March 31, 2022

IPAC-RS Comments on USP <1604> “Presentation of Aerodynamic Particle Size Distribution (APSD) Measurement Data for Orally Inhaled Drug Products” *PF48(1)*

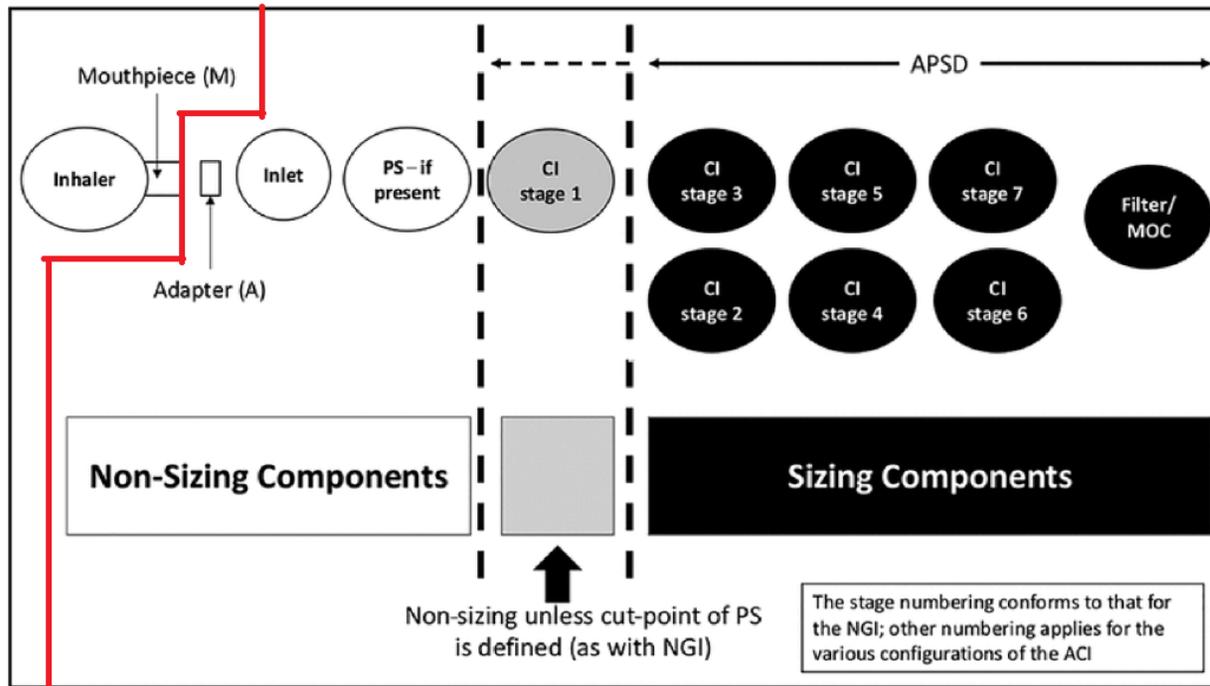
Additional Changes Suggested for Figures

1) It is recommended that Inhaler and Mouthpiece be separated from the sizing components as they are not part of the aerosol sampling system, as indicated by the red line.

2) Figure 2,3,4 -> as per annotation above (see general comment 1)
